Limerick Generating Station, Units 1 and 2
Renewed Facility Operating License Nos. NPF-39 and NPF-85
NRC Docket Nos. 50-352 and 50-353

Subject: Relief Request I4R-18 Associated with Inaccessible Emergency Service Water and Residual Heat Removal Service Water Pump Supports

Response to Request for Additional Information for Relief Request I4R-18

BYRON JACKSON SEISMIC SUPPORT MOUNTING DETAIL

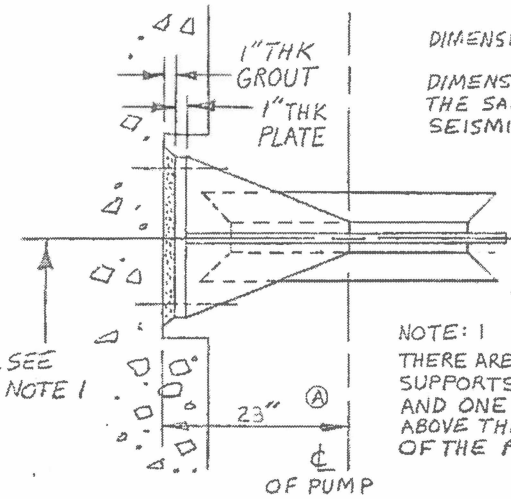
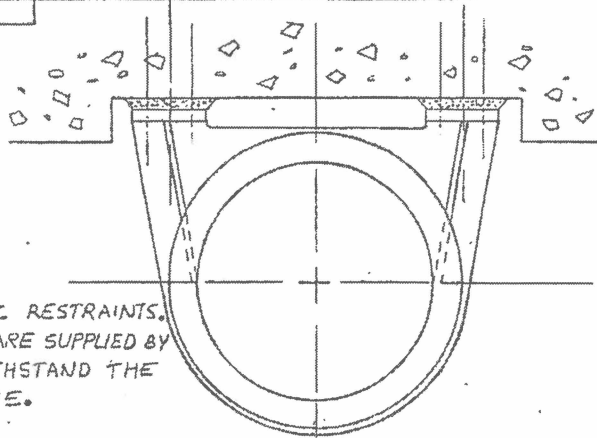
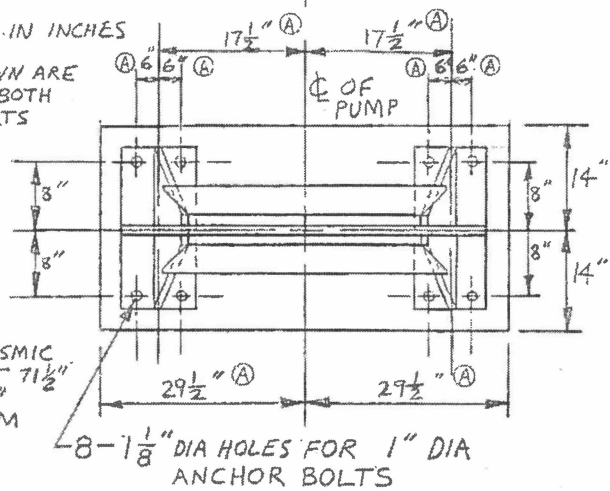
Please provide drawings which show the design/construction of the identified Emergency Service Water (ESW) and Residual Heat Removal Service Water (RHRSW) Pump upper and lower supports which includes materials of construction.

Enclosure 1 is the material parts list for the original RHRSW pumps which includes the seismic restraints. Enclosure 2 is the material parts list for the original ESW pumps which include the seismic restraints. Both parts lists identify that the seismic restraints are made from ASTM A-516 Gr. 70 material with ASTM A-193 Gr. B7 bolting. Enclosure 3 and Enclosure 4 are the design drawings of the RHRSW pump and ESW pump seismic restraints, respectively.

6.11 Seismic Restraint and Seismic Restraint Anchor Bolts

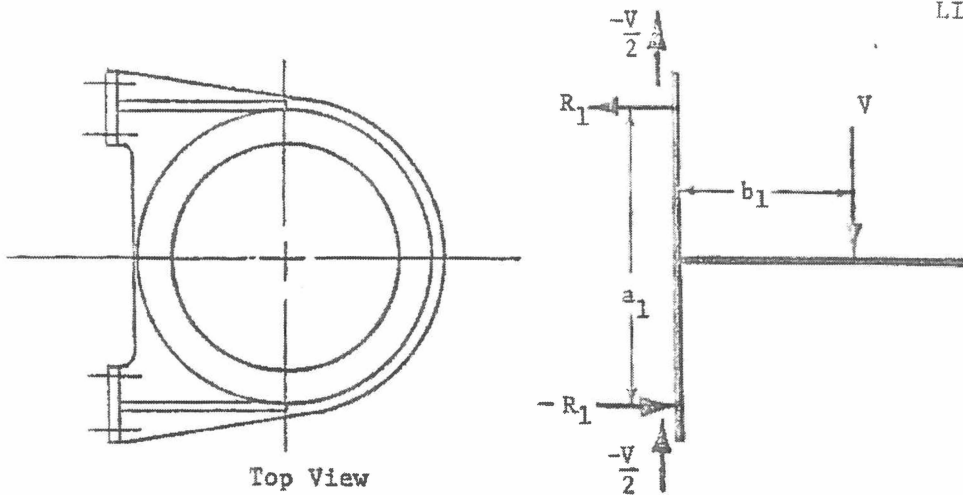
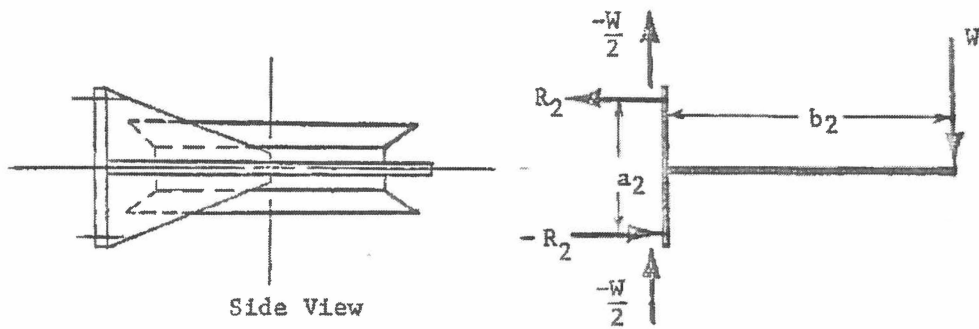
If the drawings requested in RAI #1 do not describe the normal loads (if any) and seismic loads experienced by the identified supports, please provide a document or a discussion which describes these loads.

The June 11, 2018 submittal describes a calculation which shows there is a minimum safety factor of 25 based on the operating basis earthquake (OBE). Is this true of all the identified supports? Please provide a more detailed description or excerpts from the calculation supporting the safety factor of 25 for each of the identified supports.

Enclosure 5 and Enclosure 6 are the RHRSW pump and ESW pump stress calculations for the seismic restraints and anchor bolting, respectively. These stress calculations include a discussion on the seismic loads and handling loads that were evaluated for the restraints.

Excerpts of the stress calculations have been provided in Enclosure 5 and Enclosure 6 for the RHRSW pump and ESW pump seismic restraints, respectively. The excerpts identify the calculated anchor bolt stresses and the allowable values which were used to determine the available margin or safety factor for the supports. For both the RHRSW and ESW seismic restraints, the safety factor is greater than 25 for the seismic design loads.
